No.: 07 TS - 04
January 22, 2007

TO: Service Locations
FROM: Technical Service
SUBJECT: **MBE 4000 Cylinder Head And Head Gasket Information**

Figure 1 Cylinder Head and Head Gasket

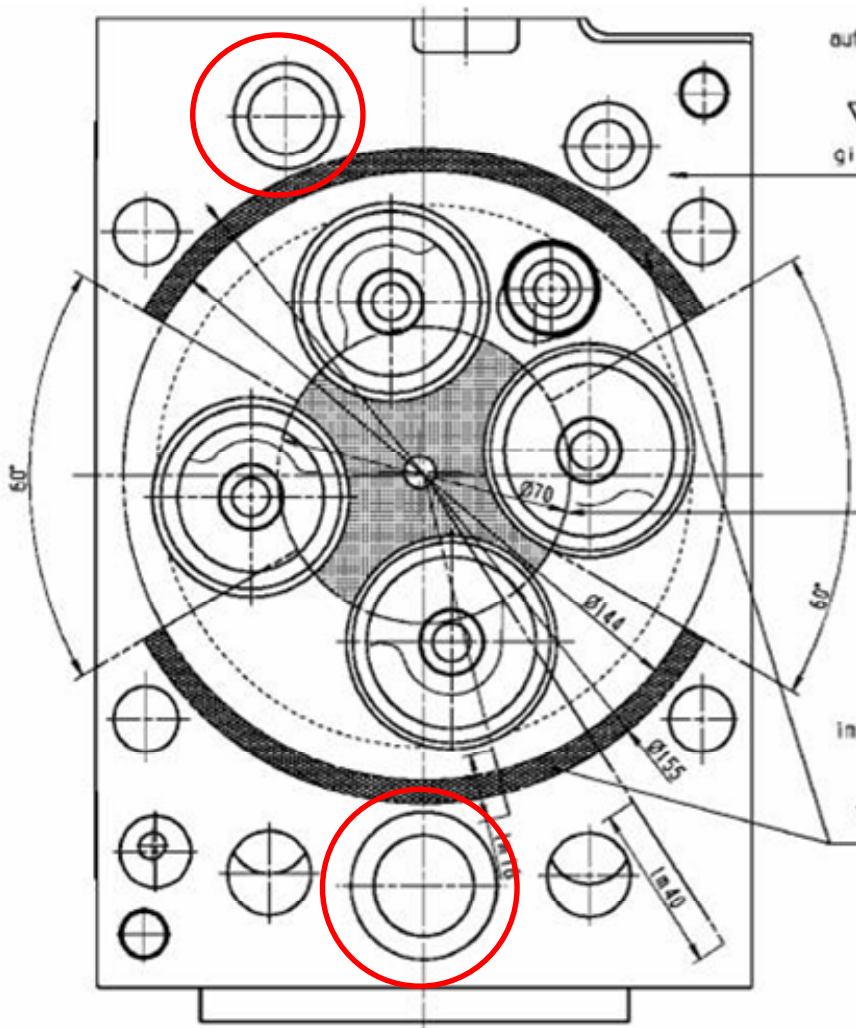
A new cylinder head and head gasket has been introduced. A 0.3mm recess was machined around each coolant inlet and outlet port in the cylinder head to give a better mating surface for the thicker rubber seal in the new head gasket. See the red circled areas below. The new cylinder head and gasket became effective with engine S/N: 0460866443 built on August 1, 2006.

- The new cylinder head and gasket *MUST* be used together. Do *NOT* use a new head with older style gaskets, or a new gasket with an older style head.
- The former heads have been superseded to the new style.
- The former head gasket (P/N: 4570161120) will remain as a serviceable part.
